May 3, 2013

RE: **RESPONSE TO REQUESTS FOR ADDITIONAL INFORMATION**  
**FILE NO. 0990332-021-AC (PSD-FL-196R)**  
**NEW NATURAL GAS FIRED BOILER (BOILER D)**

New Hope Power Company (NHPC) and Golder Associates Inc. (Golder) received a request for additional information (RAI) dated February 4, 2013 from the Florida Department of Environmental Protection (FDEP) regarding the new natural gas fired boiler at the Okeelanta cogeneration facility. Additionally, Golder and NHPC received an email dated April 15, 2013 from Stan Krivo of the Environmental Protection Agency (EPA) to Melody Lovin of FDEP. This response letter addresses both the FDEP RAI and the EPA email.

**FIGURE: 1**

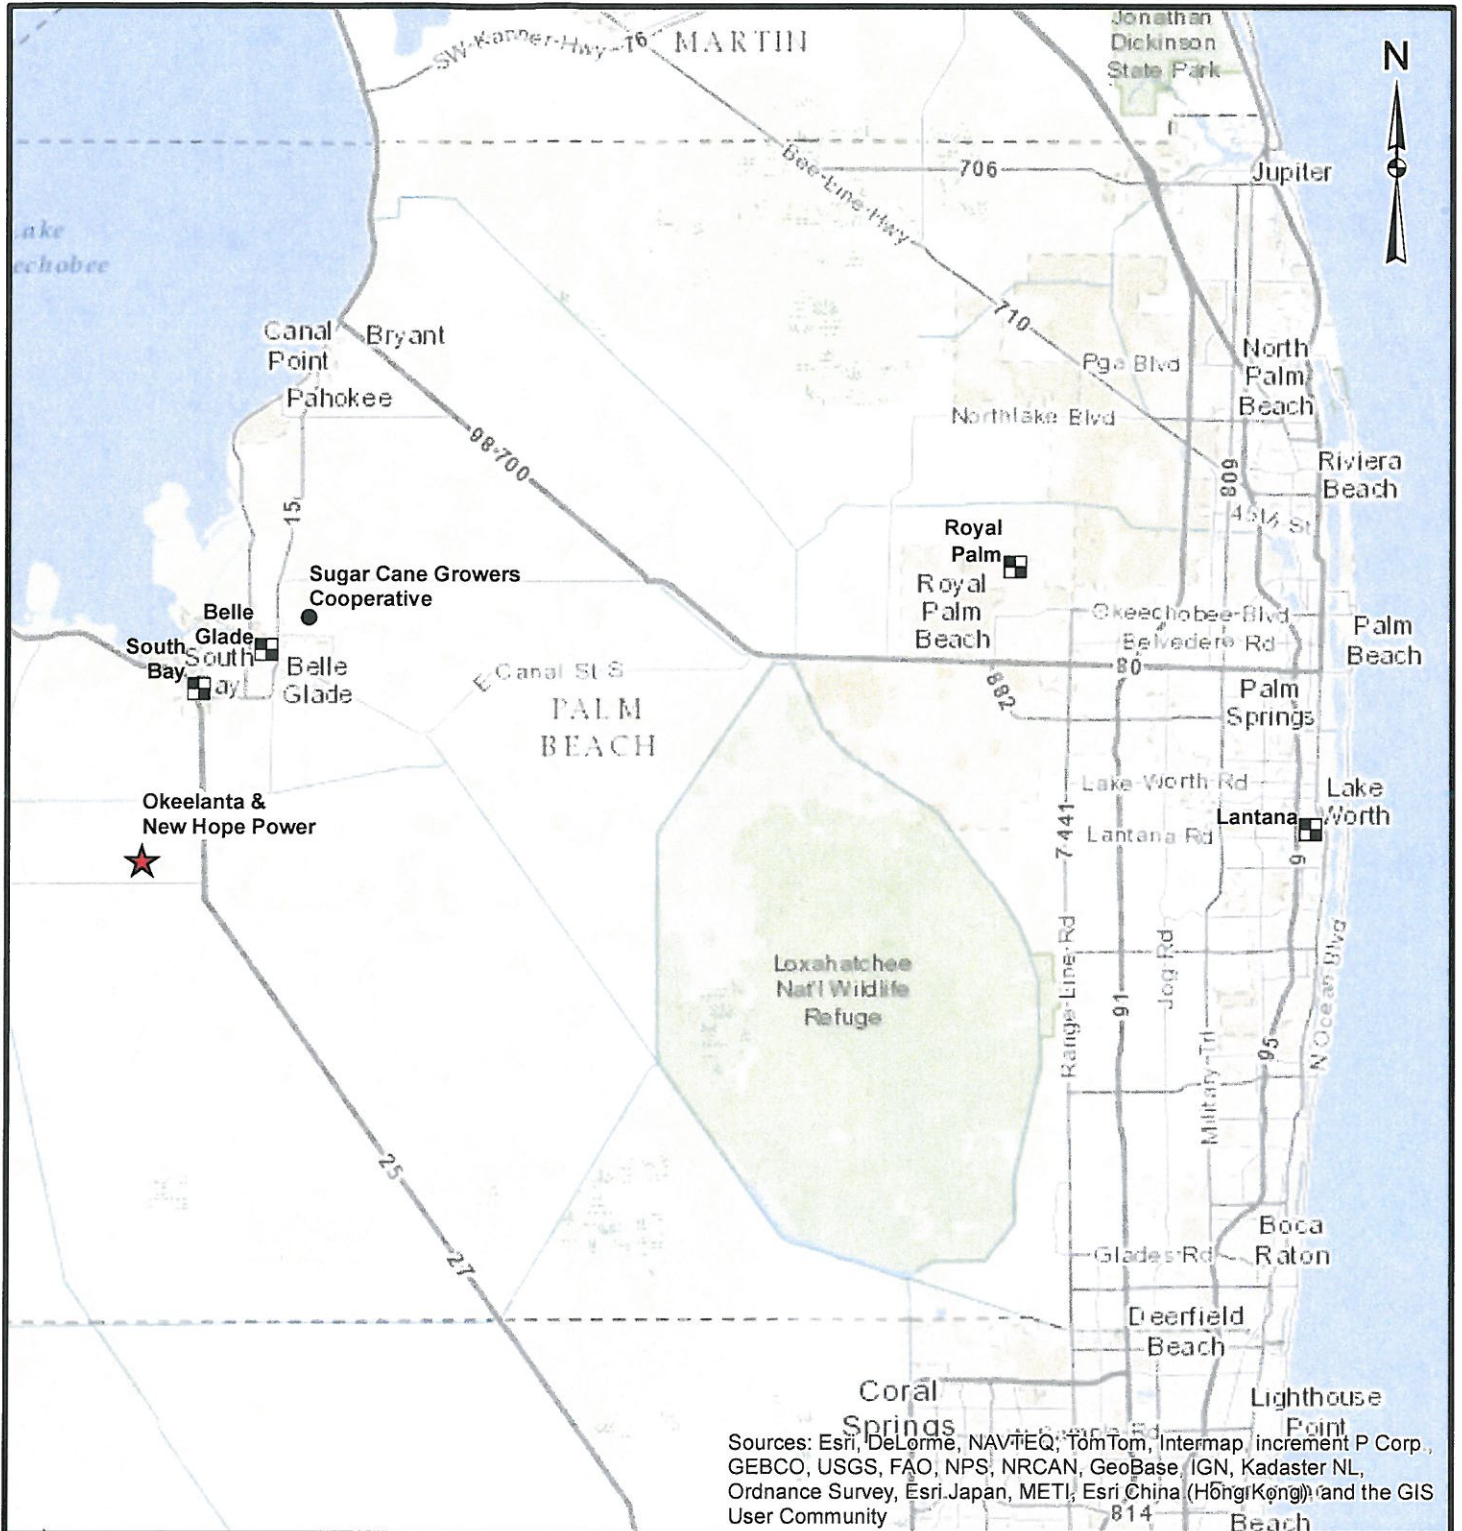
**The representativeness of the selected existing  $\text{NO}_2$  ambient monitoring data for the project location was not provided. Sections 4.2, 6.5.3, and 6.8 indicate the selected Lantana  $\text{NO}_2$  monitor is considered conservative and more than adequately represents the potential impacts due to emission sources not included in the modeled NAAQS compliance assessment. The bases for these statements should be provided and explained.**

**Response:** The ambient FDEP monitoring station at Lantana in Palm Beach County is the closest nitrogen dioxide ( $\text{NO}_2$ ) monitor to the project site. The monitor is located approximately 68 km east of the project site on the Florida east coast (see Figure 1). This monitor is located near more industrialized and commercialized areas compared to the project site.

**Response:** Based on the project's  $\text{NO}_x$  emissions, the project's  $\text{NO}_x$  impacts on the ambient ozone levels in the region (i.e., Palm Beach, Broward, and Miami-Dade Counties) are expected to be minimal. Since ozone is a regional pollutant,  $\text{NO}_x$  emissions from sources located in the three counties are expected to contribute to ozone formation in this region. In fact, FDEP developed an air quality maintenance plan in 2002 for the three counties to comply with the NAAQS [*Air Quality Maintenance Plan (2005-2015), Dade, Broward, and Palm Beach Counties, December 2002*]. In the FDEP plan, both  $\text{NO}_x$  and volatile organic compound (VOC) emissions and emission reductions from a variety of sources were evaluated and measures were identified to ensure that these areas maintained compliance with the NAAQS. As a result, the ozone concentrations measured in these counties have continued to comply with the NAAQS. A summary of the ozone concentrations measured in Palm Beach County from 2010 to 2012 is presented in Table 1. The locations of these monitors are shown in Figure 1.
